Planning Rationale & Urban Design Brief

Site Plan Control Application

Block 16 - Gas Bar, Commercial Building/Drive-Through Restaurant & Car Wash

2983 Navan Road

Figure 20 Landscape Plan

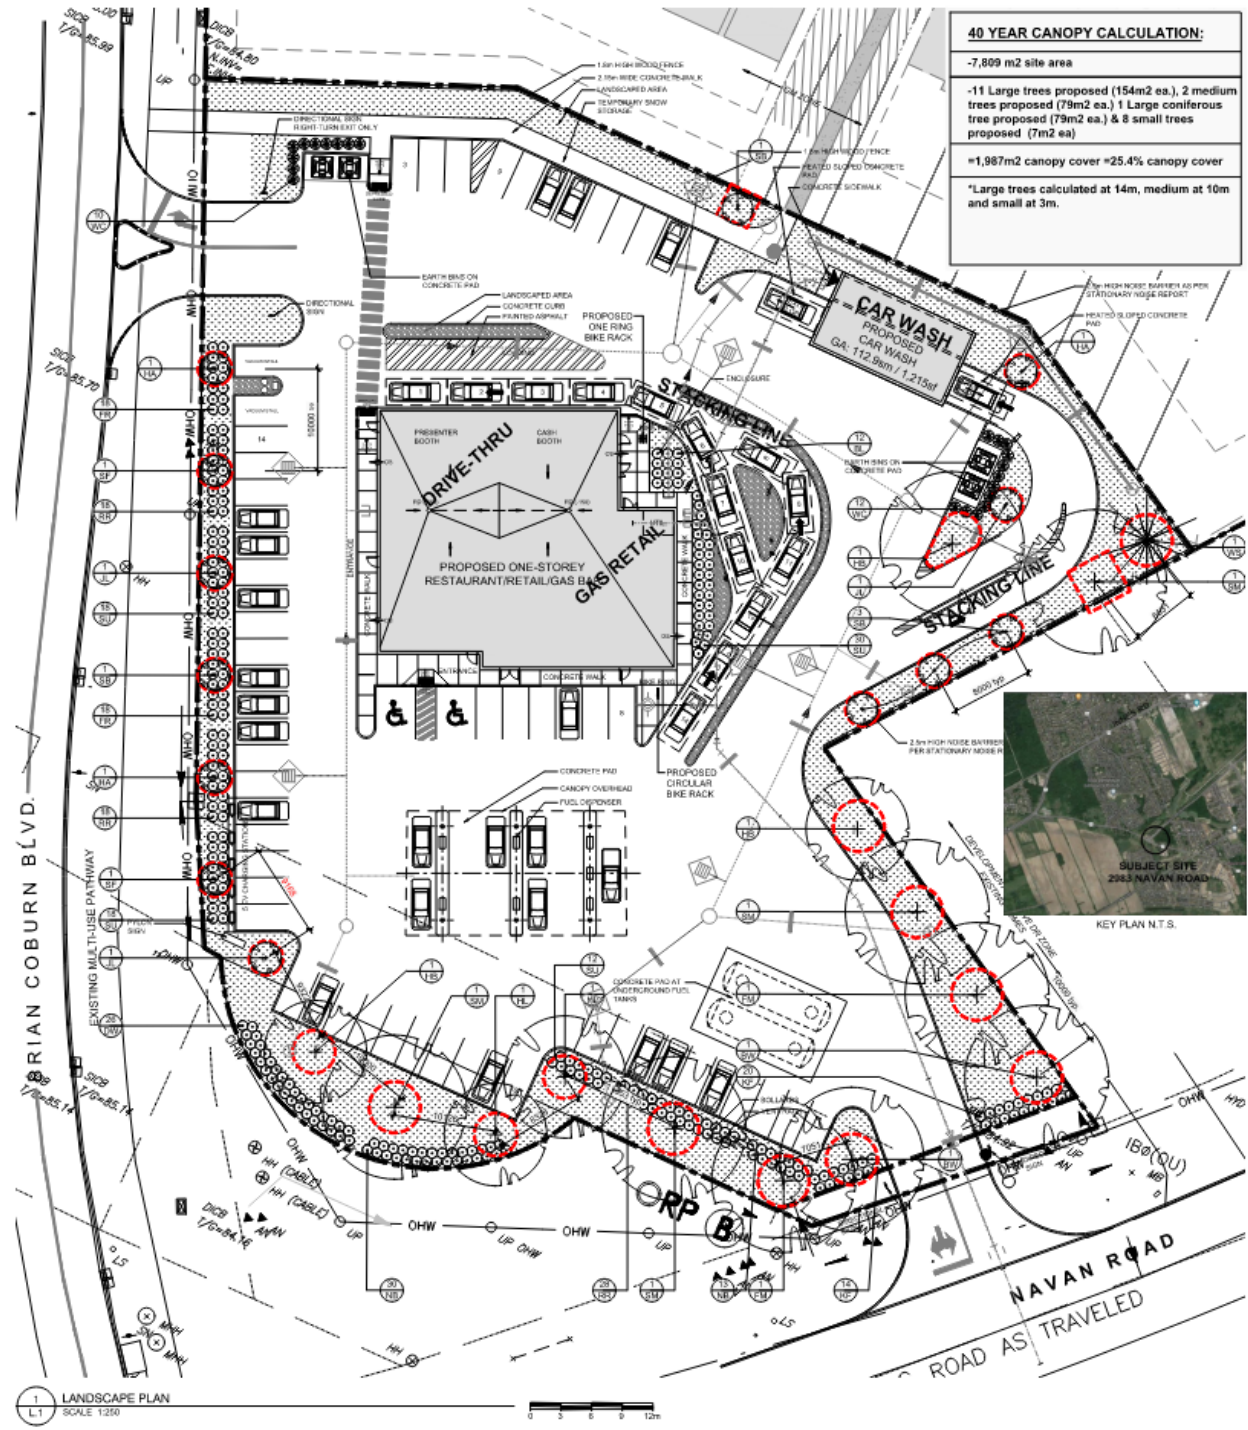
Comment from the City: *Landscaping - Extensive tree and shrub planting is need on this site, in particular to soften the interface with the existing and future residential and to enhance the ROW.*

JLR Response: The Landscaping Plan provided by James B. Lennox & Associates (Figure 10) shows the variety of native and non-native trees and shrub plantings to be added to the site. The existing residential homes on Navan Road are clearly separated from the site by large trees, as can be seen in Figure 11. The site entrance off Navan Road is enhanced by the addition of trees and shrubs as can be seen in Figure 11. The addition of landscaping along this frontage is being designed with the understanding that there are significant utilities present in the area including both Hydro and Gas. The entrance way off of Brian Coburn is enhanced by trees and shrubs as can be seen in Figure 22.
